The Calcutta Gazette

WEDNESDAY, OCTOBER 25, 1922.

Notices to Mariners.

Reproduction of Portion of Chart N°986.

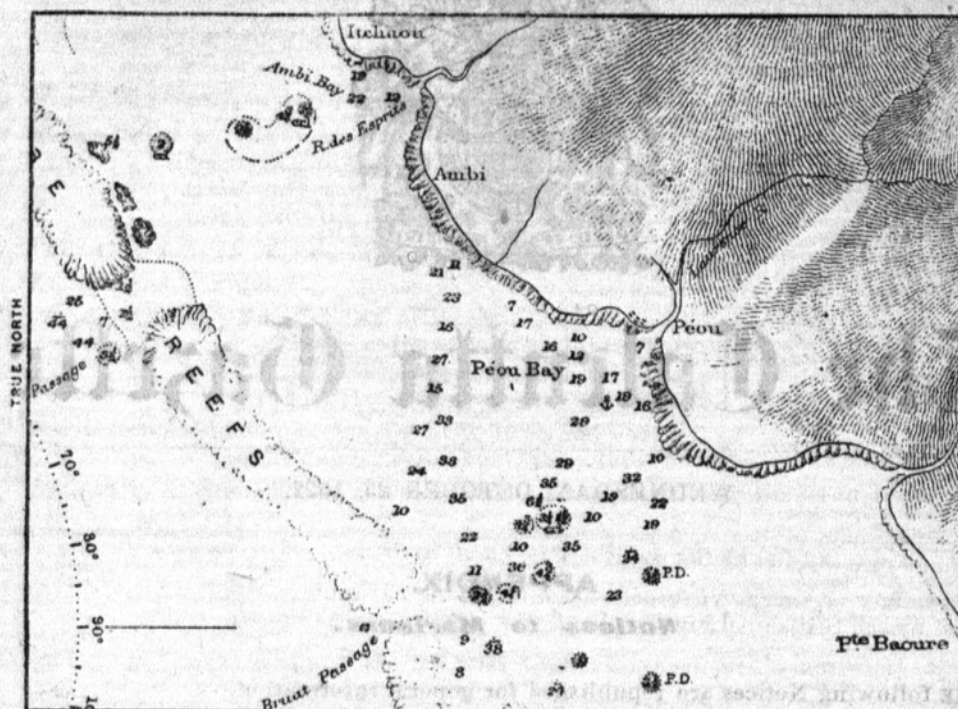
Details.—The accompanying reproductions of portions of charts Nos. 986 and 17 show the necessary amendments to the charts with regard to coastline, reefs, shoals and depths in the vicinity of Péou and Ambi bays.

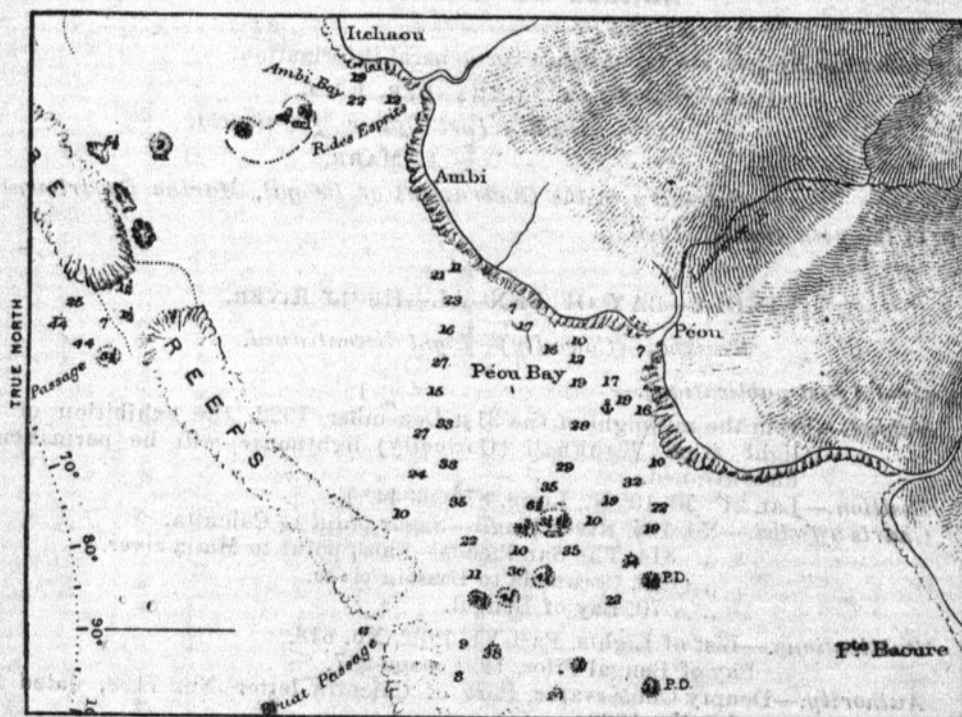
Details.—The accompanying reproductions of portions of charts Nos. 986 and 17 show the necessary amendments to the charts with regard to coastline, reefs, shoals and depths in the vicinity of P éou and Ambi bays.

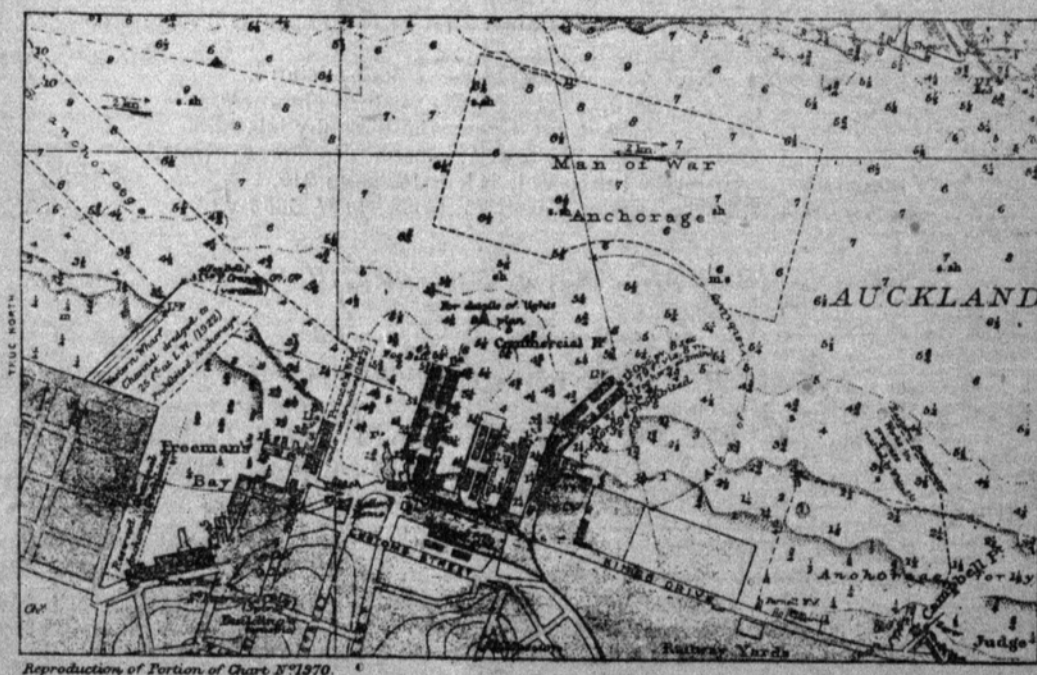
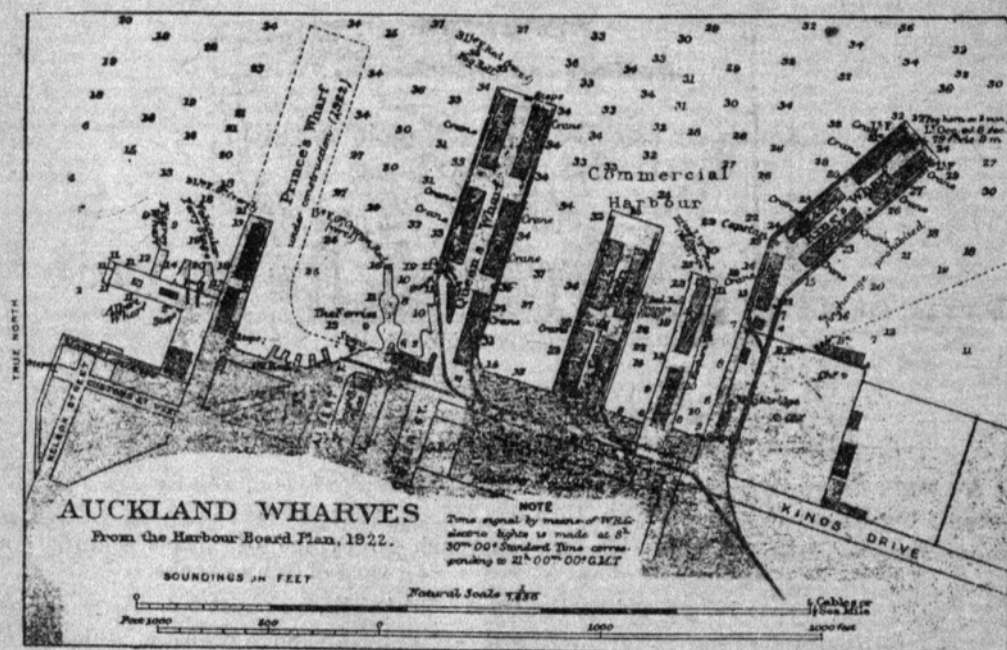
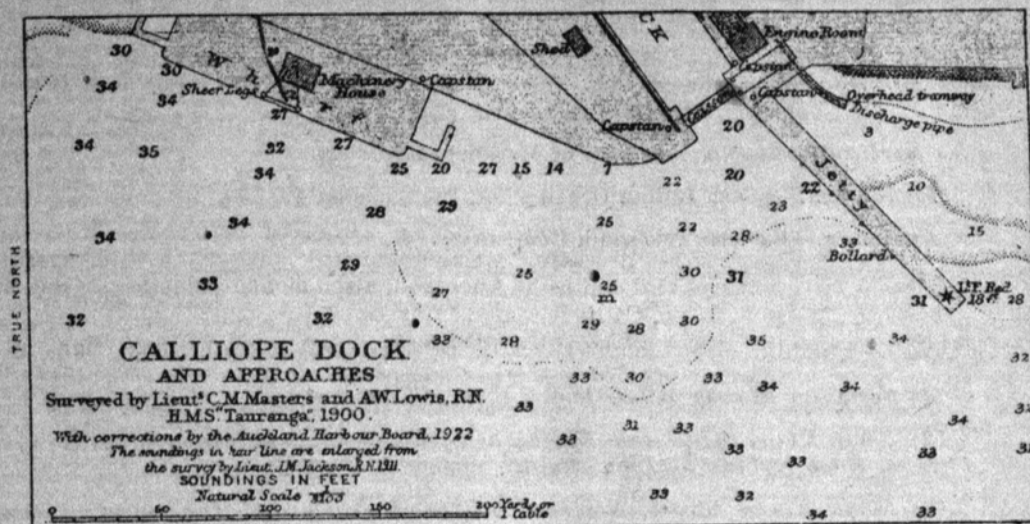
Details.—The accompanying reproductions of portions of charts Nos. 1970 and 1896 show necessary amendments to the charts with regard to wharves and depths at Auckland, also amended depths in the approaches to Calliope dock at Devonport.

Note.—From the reproductions it will be seen that a *fixed white light* now marks the new Western wharf at Auckland.

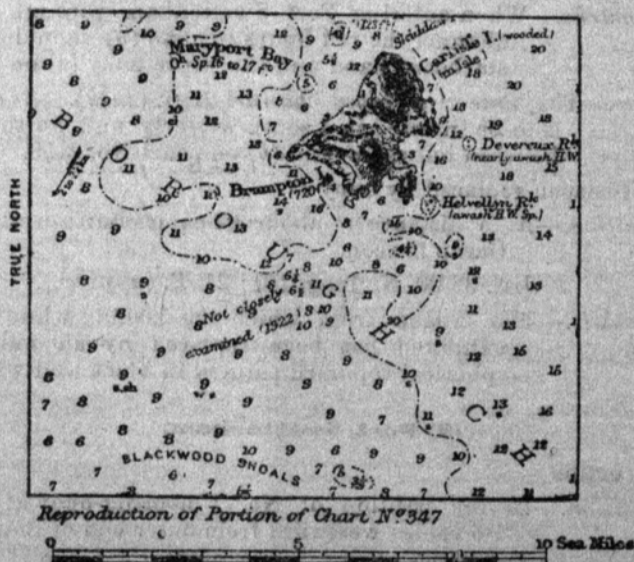
Details.—The accompanying reproduction of a portion of chart No. 347 shows the necessary amendments to the chart with regard to decreased depths south-westward of Brampton island.

Reproduction of Portion of Chart N° 1472.

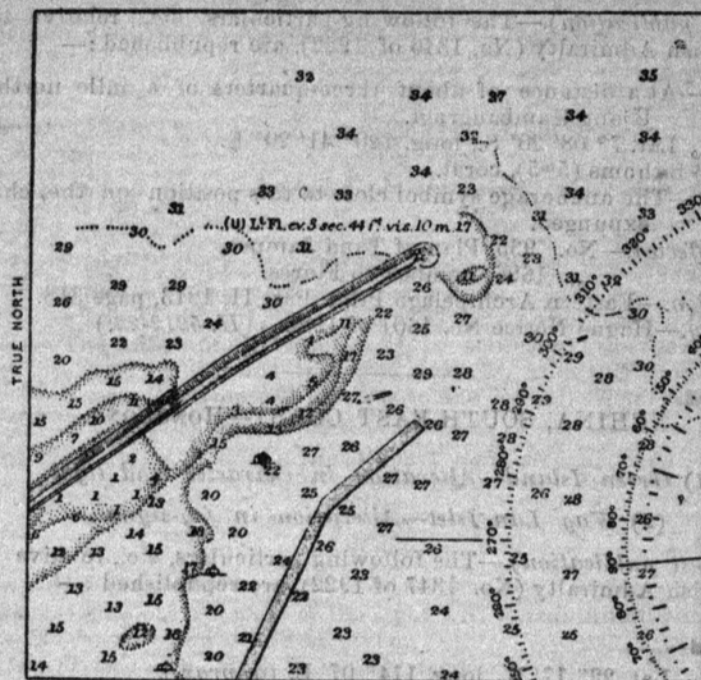
Details.—Amendments to the undermentioned plan on chart No. 1472 with regard to the moles, depths and mooring buoys at the entrance to Koombanah harbour, embodying the latest information received, are shown on the accompanying reproduction of a portion of that plan.

Reproduction of Portion of Chart N° 3732.

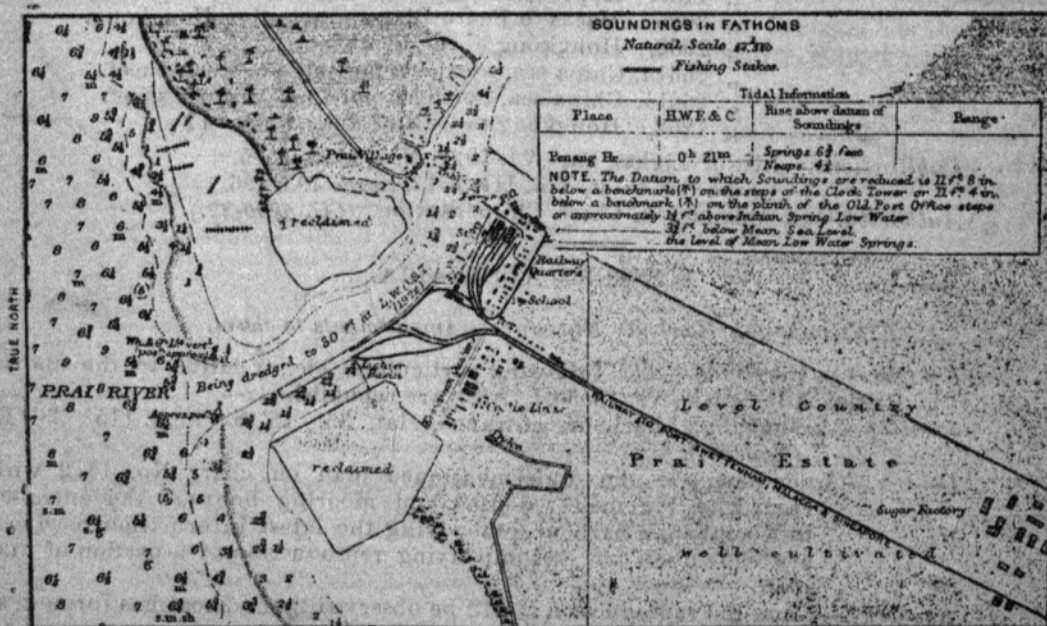
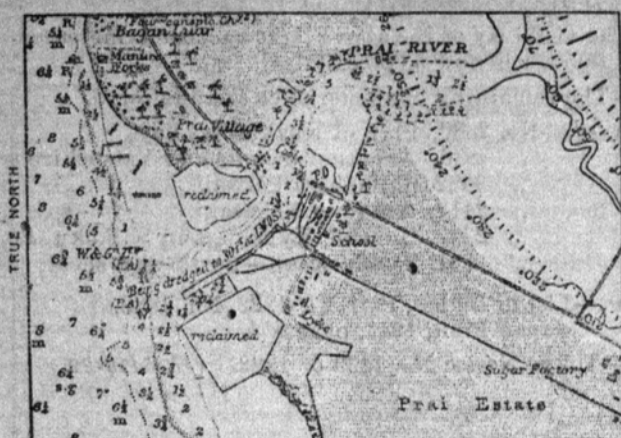
Details.—General amendments to the charts in regard to Prye river entrance, embodying the latest information received, are shown on the accompanying reproductions of portions of charts Nos. 3732 and 1366.

Reproduction of Portion of Chart N°1970.

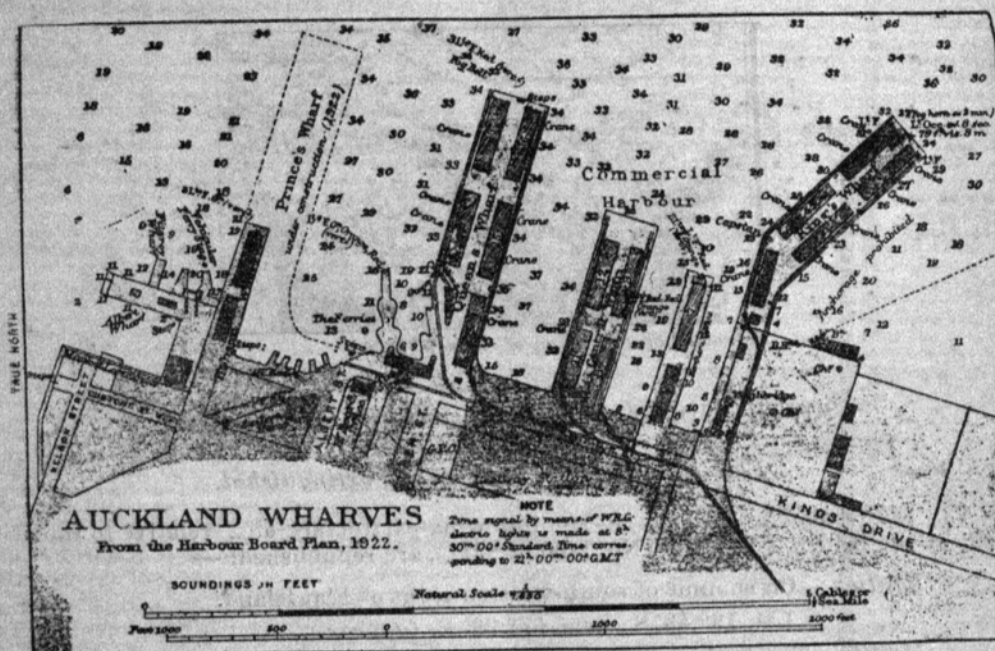
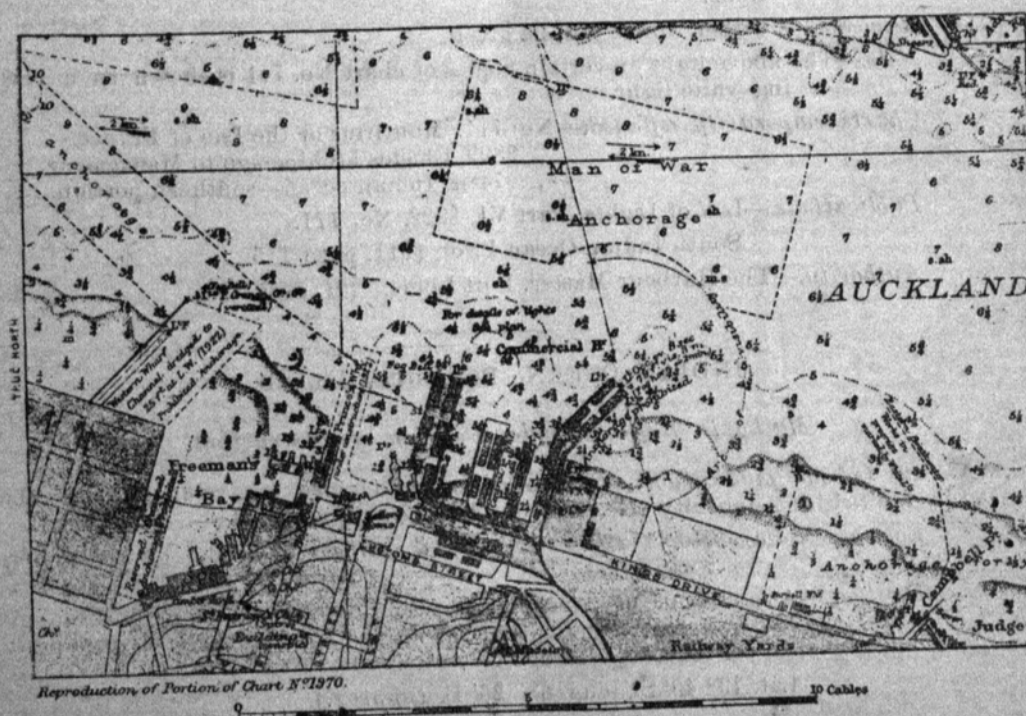
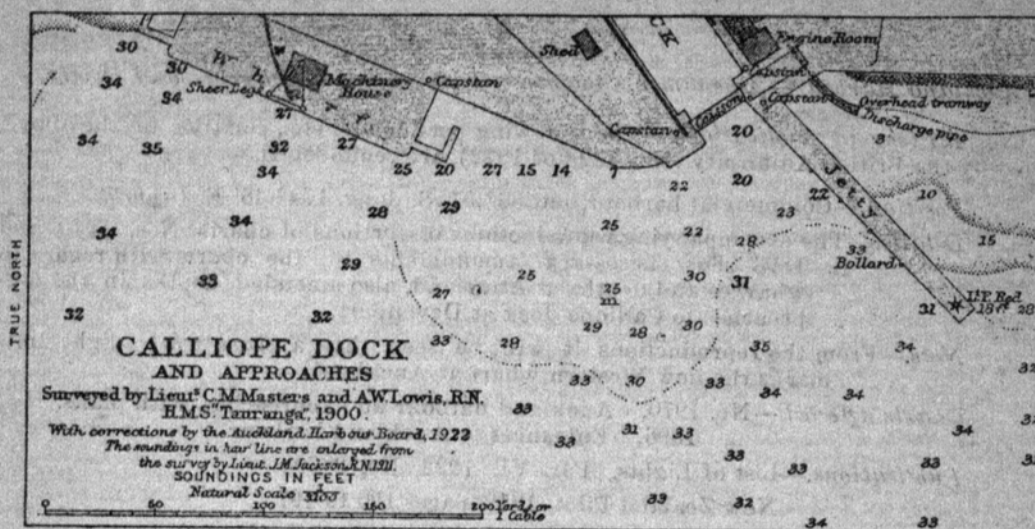
Details.—The accompanying reproductions of portions of charts Nos. 1970 and 1896 show necessary amendments to the charts with regard to wharves and depths at Auckland, also amended depths in the approaches to Calliope dock at Devonport.

Note.—From the reproductions it will be seen that a *fixed white* light now marks the new Western wharf at Auckland.

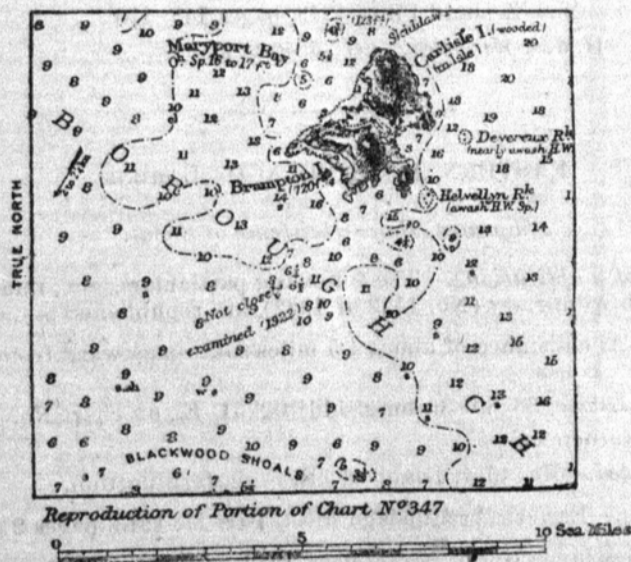
Details.—The accompanying reproduction of a portion of chart No. 347 shows the necessary amendments to the chart with regard to decreased depths south-westward of Brampton island.

Reproduction of Portions of Chart No. 2089.

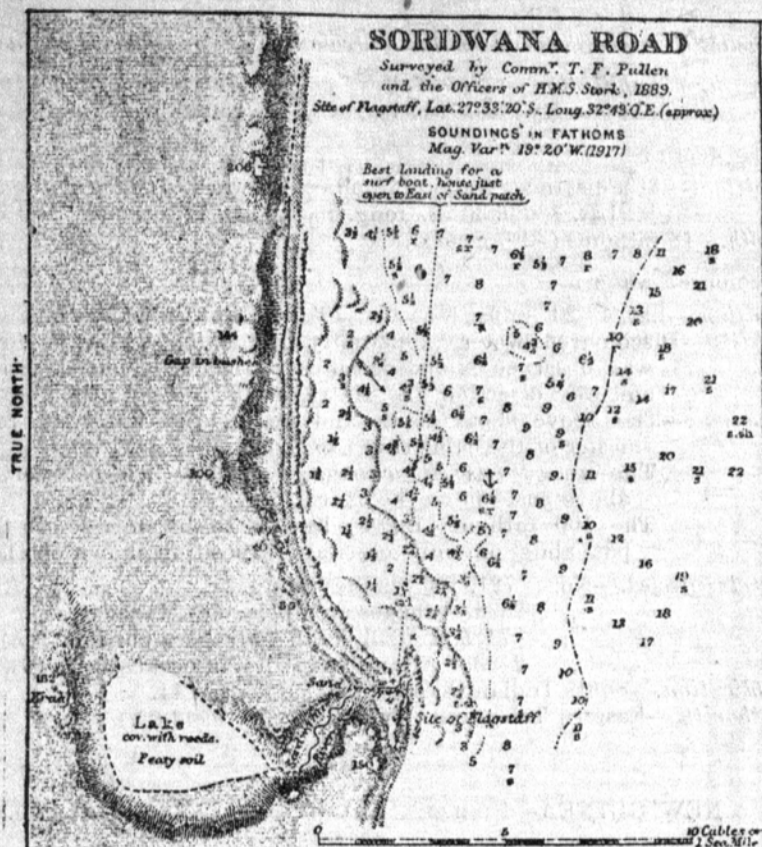
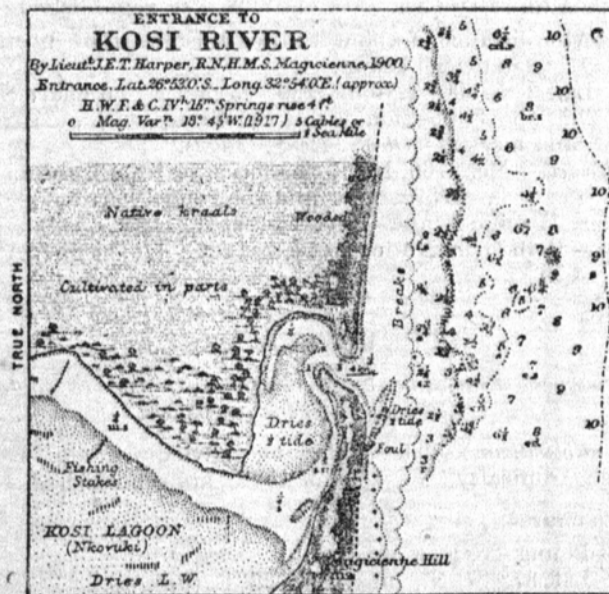
Details.—The accompanying reproduction of the plans of Sordwana road and entrance to Kosi river on chart No. 2089 shows the necessary amendments to the chart with regard to shoals and depths in the two localities referred to.

Reproduction of Portion of Chart No. 3642

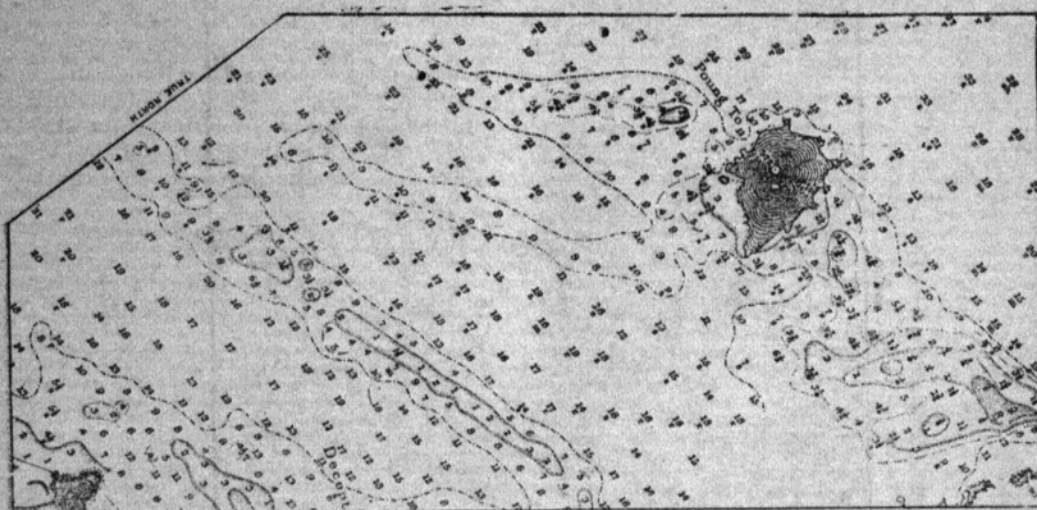
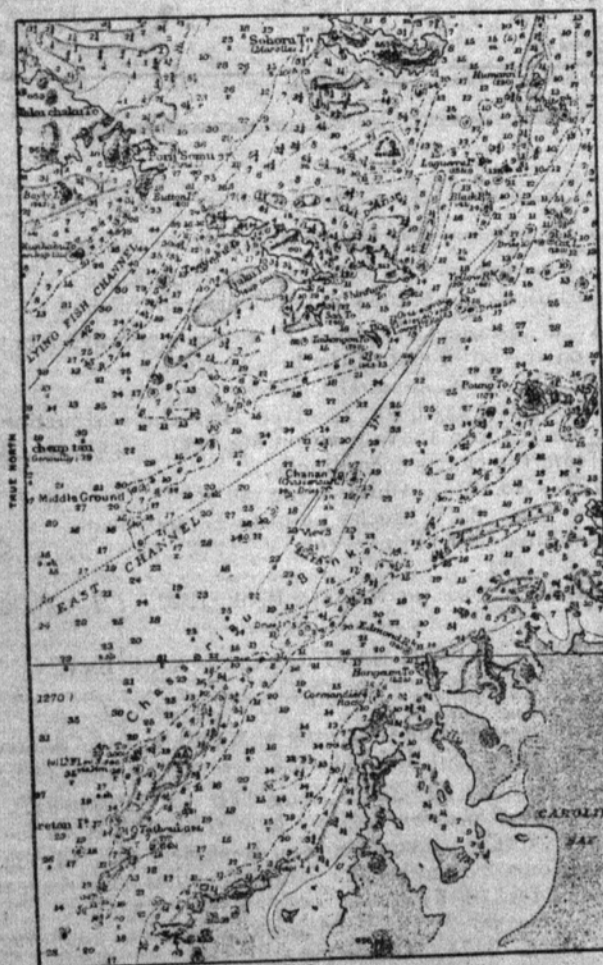
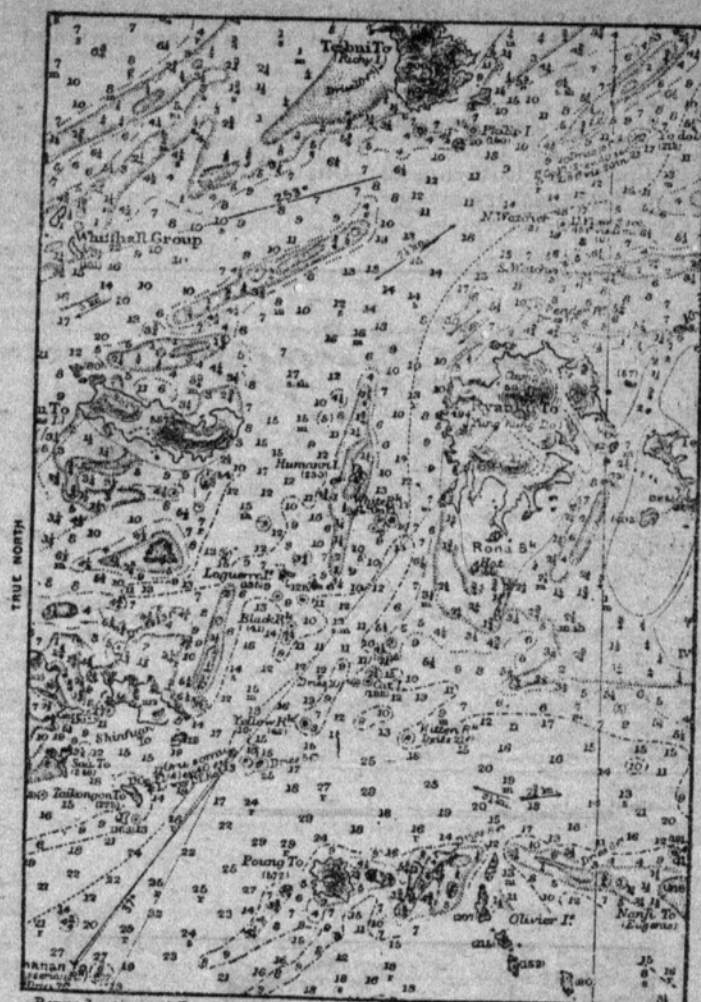
Details.—The accompanying reproductions of portions of charts Nos. 3642 and 1258 show the necessary amendments with regard to depths and shoals in East and Flying Fish channels and their vicinities.

Remarks.—The above rock and shoal, which are to be inserted on chart No. 3642, are not included in the reproduction of the portion of that chart.

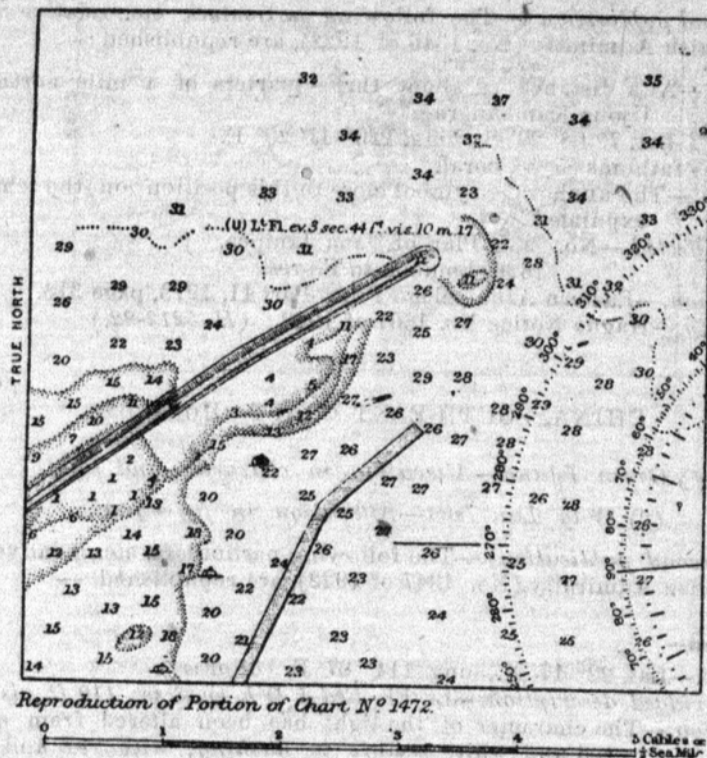
Details.—Amendments to the undermentioned plan on chart No. 1472, with regard to the moles, depths and mooring buoys at the entrance to Koombanah harbour, embodying the latest information received, are shown on the accompanying reproduction of a portion of that plan.
